WCAP 11524-A
Addendum 1
Revision 2-A

THE 1981 VERSION OF THE
WESTINGHOUSE ECCS EVALUATION
MODEL USING THE BASH CODE
ADDENDUM 1: POWER SHAPE
SENSITIVITY STUDIES

SUBJECT: ACCEPTANCE FOR REFERENCING OF ADDENDUM 1 TO WCAP-10266, BASH POWER
SHAPE SENSITIVITY STUDIES

SAFETY EVALUATION BY THE OFFICE OF NUCLEAR REACTOR REGULATION
RELATING TO BASH POWER SHAPE SENSITIVITY STUDIES
WCAP-10266, REVISION 2, ADDENDUM 1

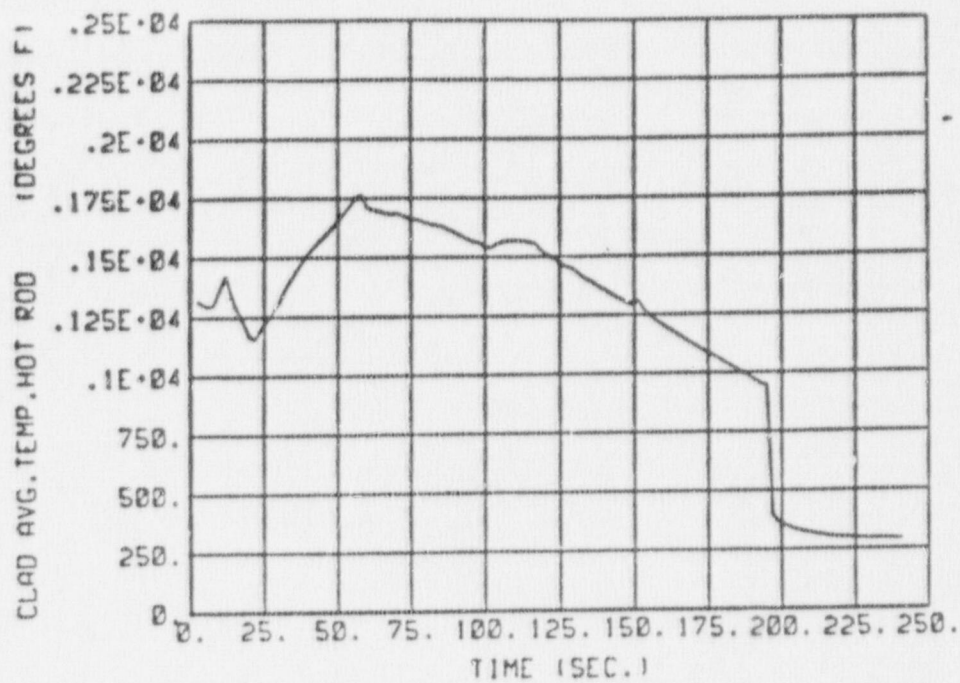
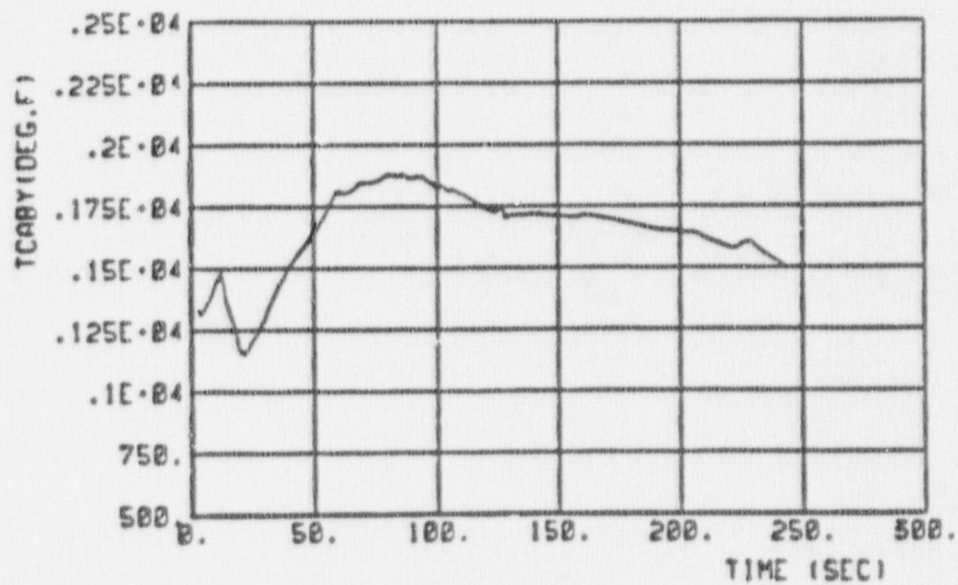
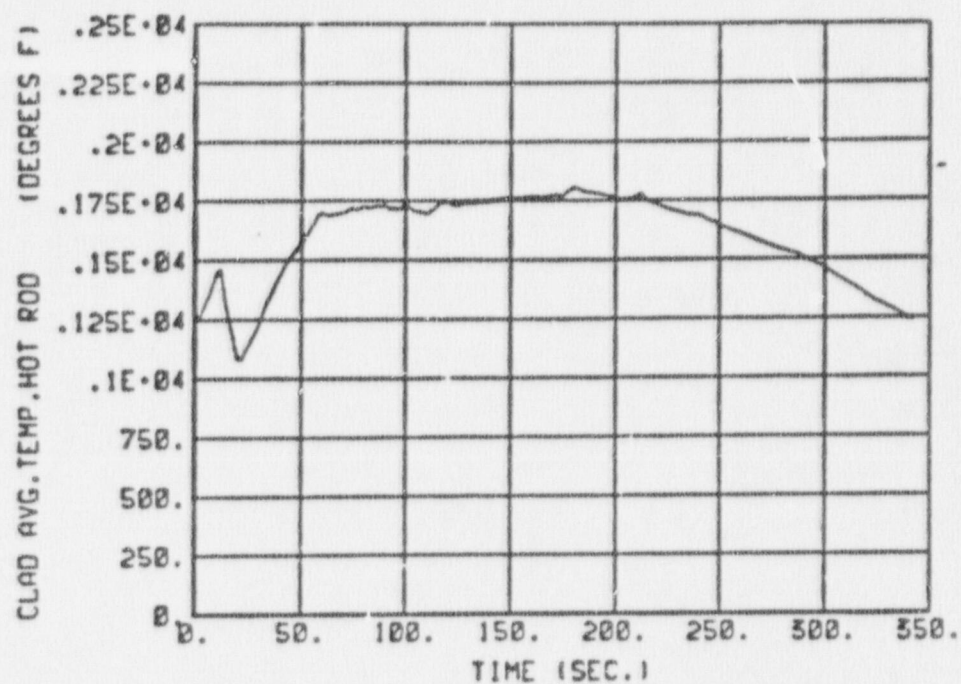
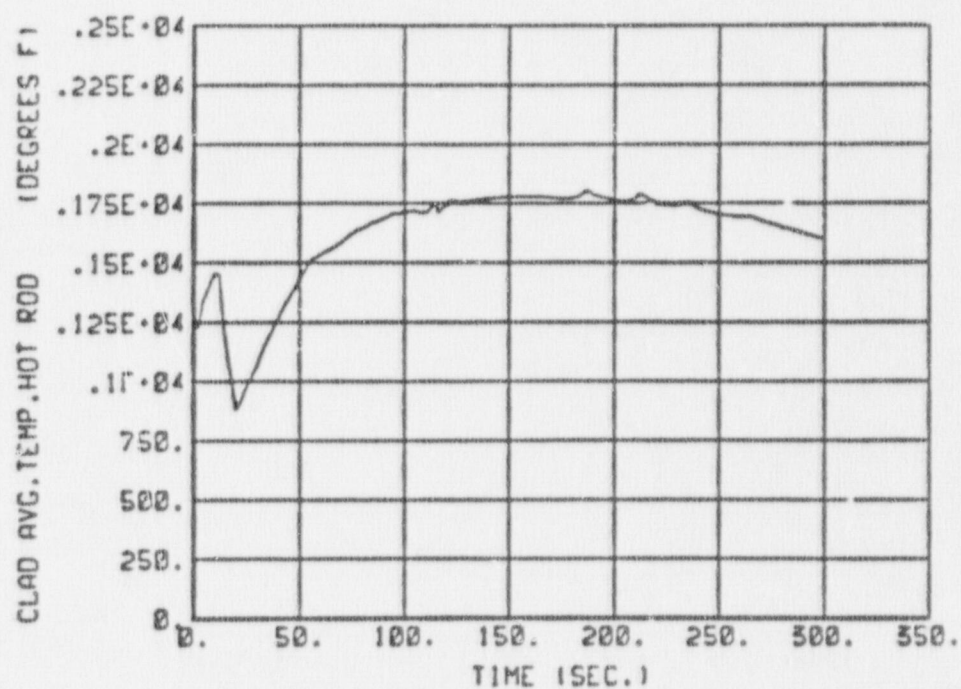
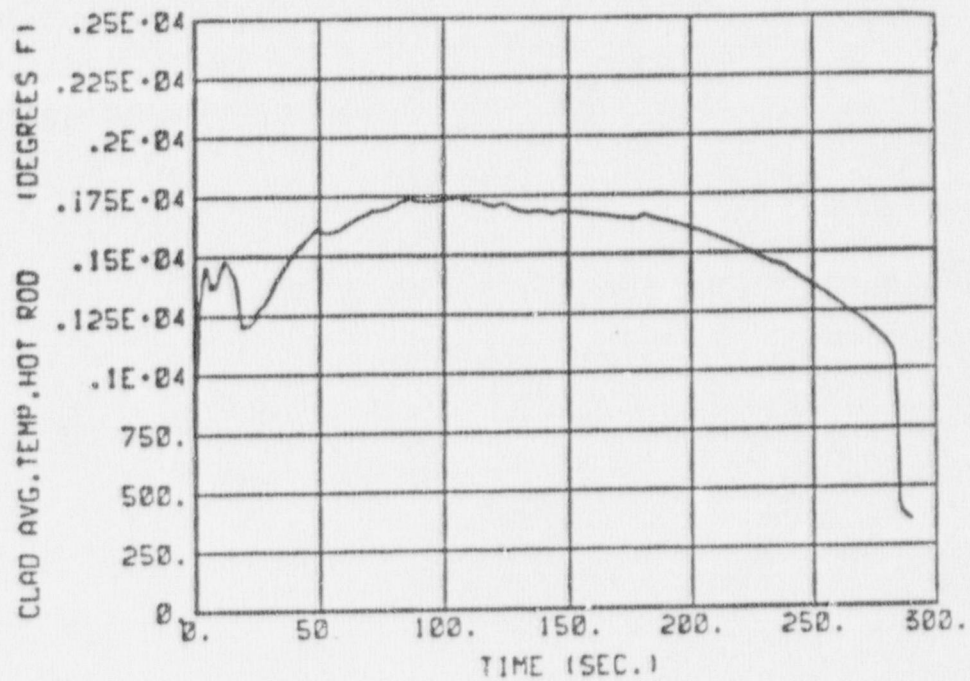
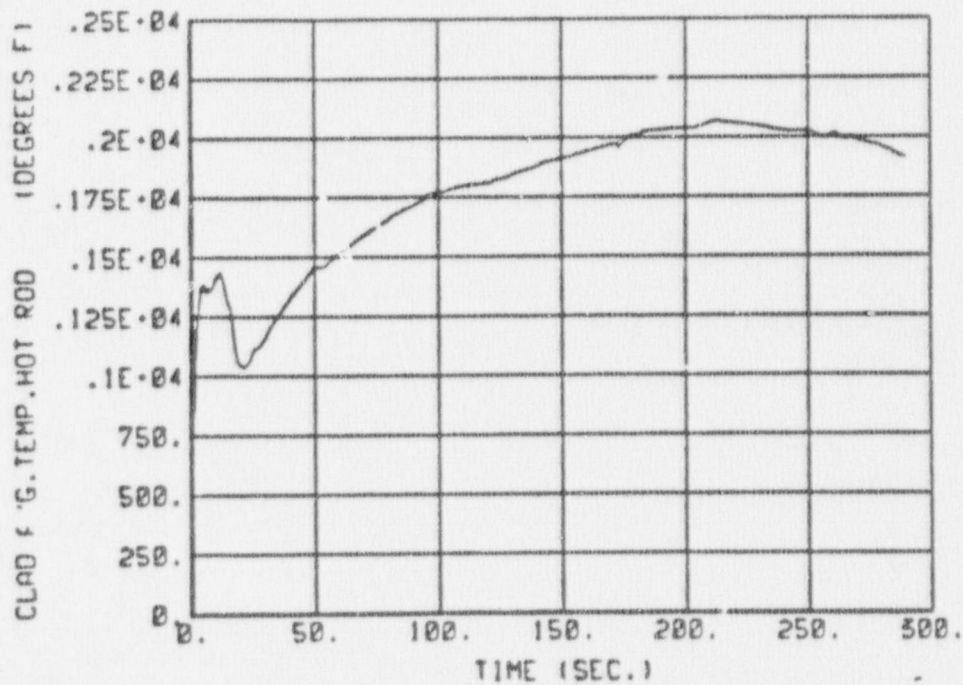
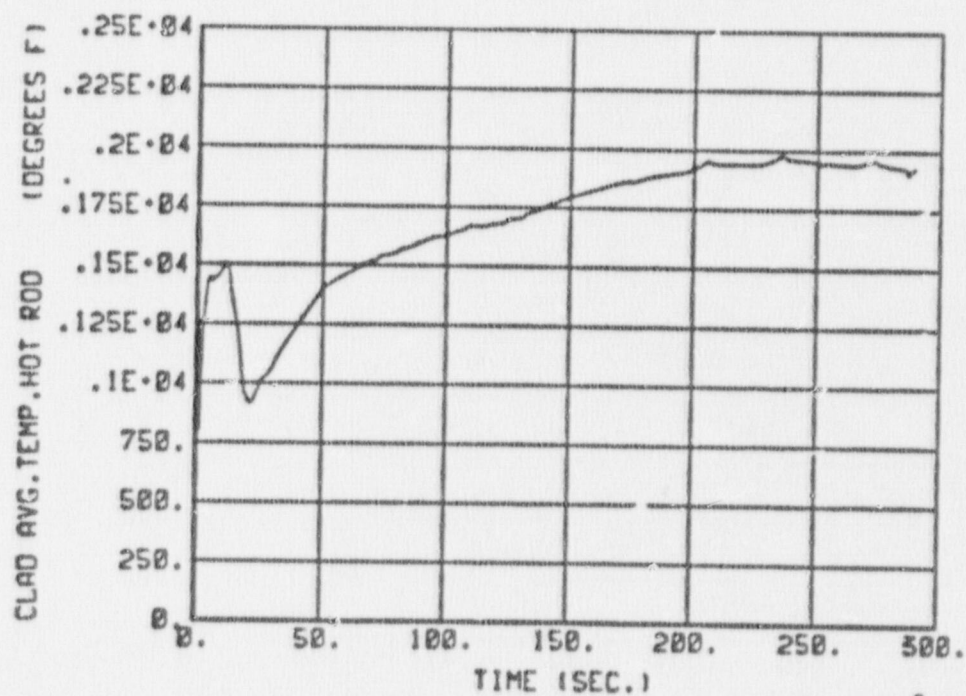
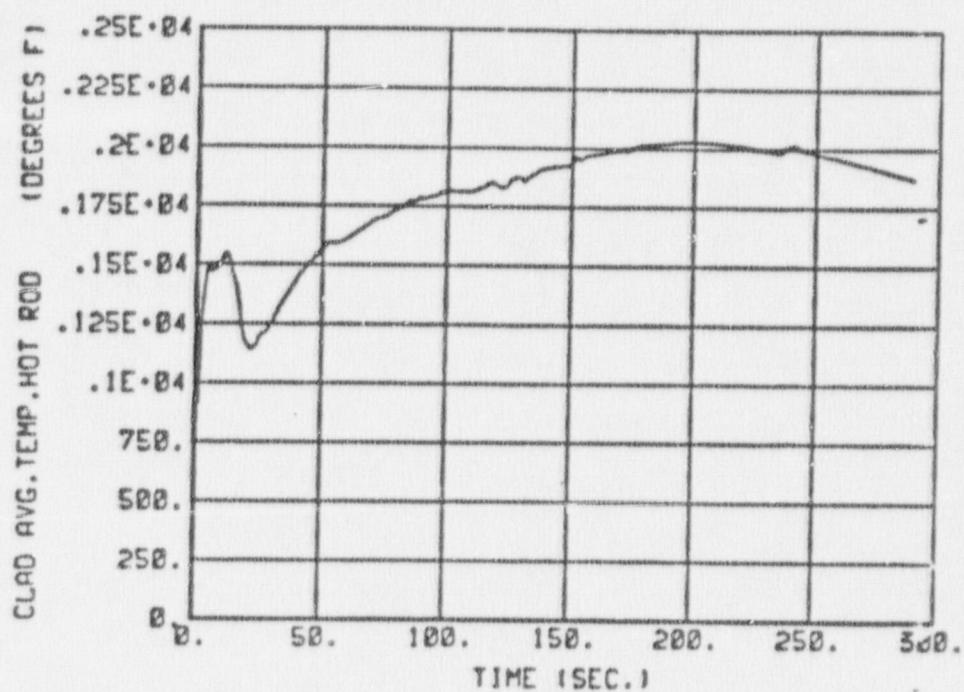
The results of the studies are shown in Figures J-5 and J-6 of the report where axial cladding temperature profiles for the 4, 6, 8, and 10 foot peaked power shapes are shown for the beginning of core recovery (BOCREC), and Figures J-11 through J-14 where the PCT history during reflood periods are shown for the various power shapes studied. The PCT comparisons for these power shapes are summarized in Table J-1 for both three and four loop plants.

The results clearly show that the 6-foot peaked (chopped cosine) power shape results in the highest PCT with the 4-foot peaked shape having the lowest PCT among the four shapes studied. These studies were performed with the maximum total peaking factor, F_q , of 2.32. An additional confirmatory study (Ref. 5) was also done with F_q of 2.5 to confirm the same trend for other total peaking factors. Only two peak locations (6-foot and 7.5-foot peak) were studied for $F_q=2.5$. The results again show that the 6-foot peak cosine shape yield the highest PCT. We therefore conclude that Westinghouse has adequately confirmed the conclusion of WCAP-8340 that the 6-foot peak chopped cosine shape is the most limiting power shape which can be used for plant licensing calculations.

The staff has reviewed the power shape sensitivity study of WCAP-10266, Revision 2, Addendum 1. We concur with the conclusion that the chopped cosine axial power shape is the limiting power shape for LOCA analysis using the BASH code. Therefore, the power shape study conclusion of WCAP-10266, Addendum 1 is acceptable. This acceptance is only applicable to the Westinghouse three-and-four-loop plants, since no analysis was performed for the two-loop plant.
